Logic Level Converter Fix

NixieClock

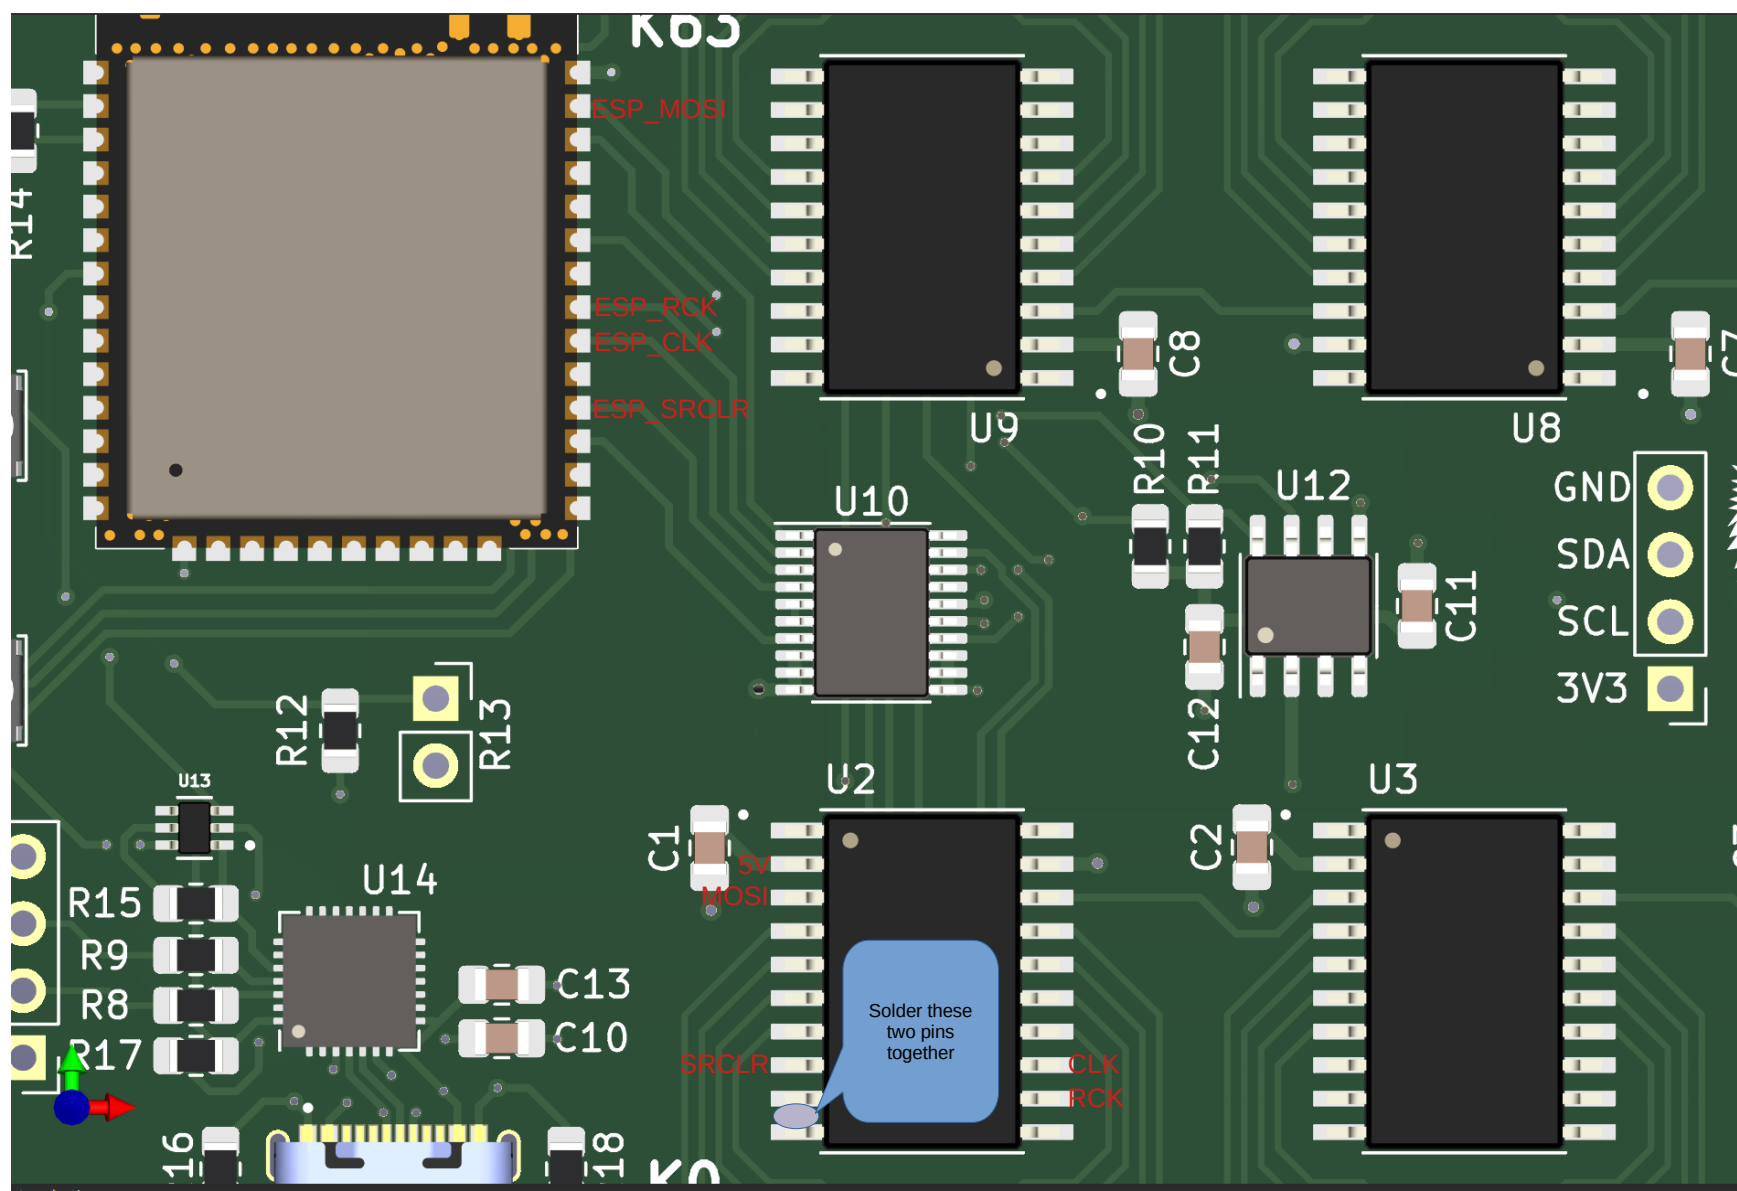
- Do not solder U10
- Connect the converter board according to following pages

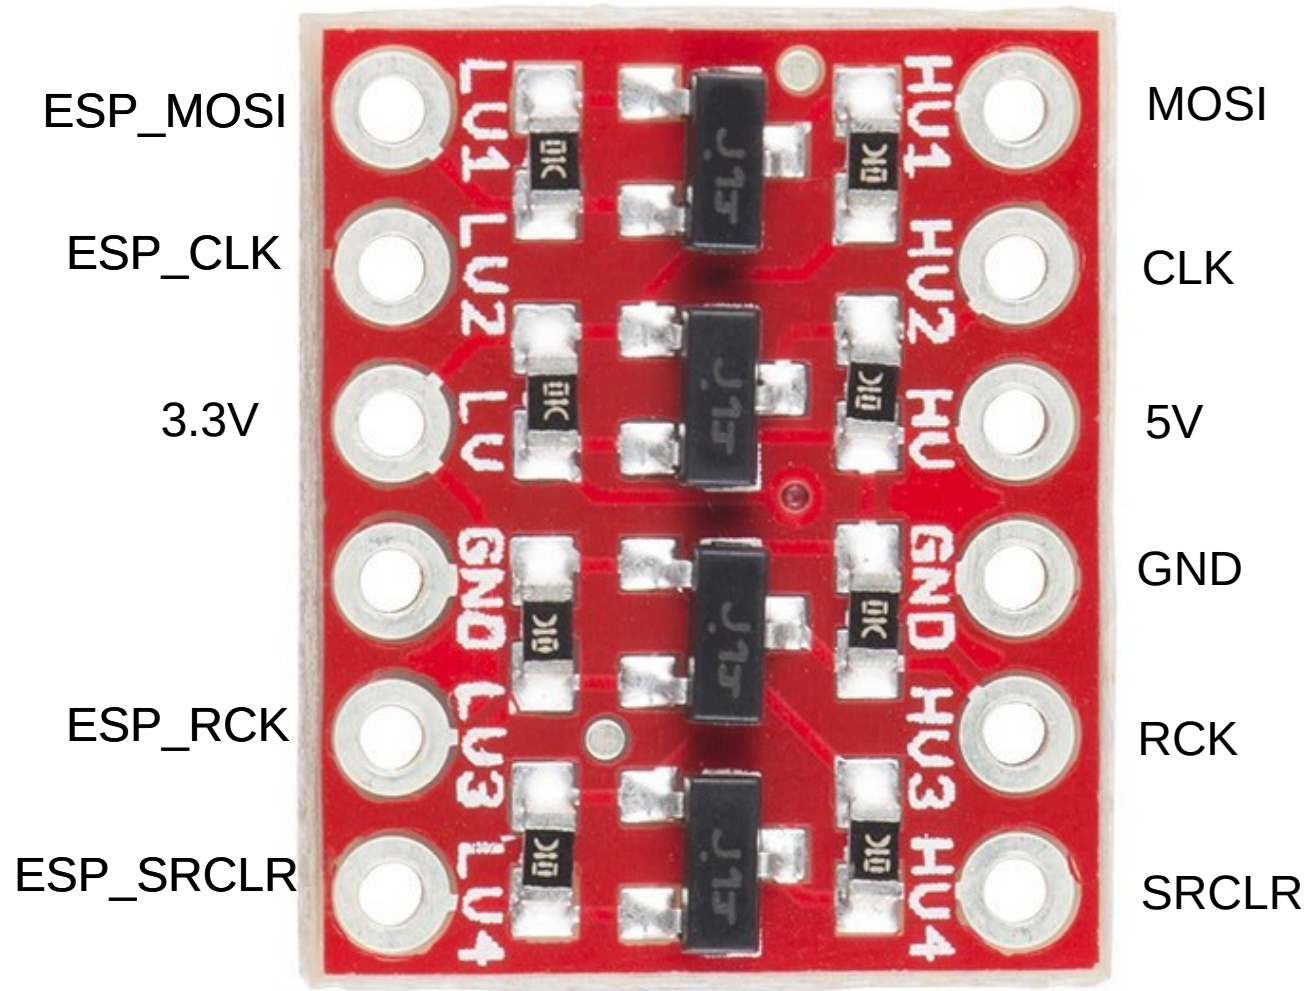
Only one GND connection is needed

Take 3.3V and GND from connector socket on the right (with SCL and SDA
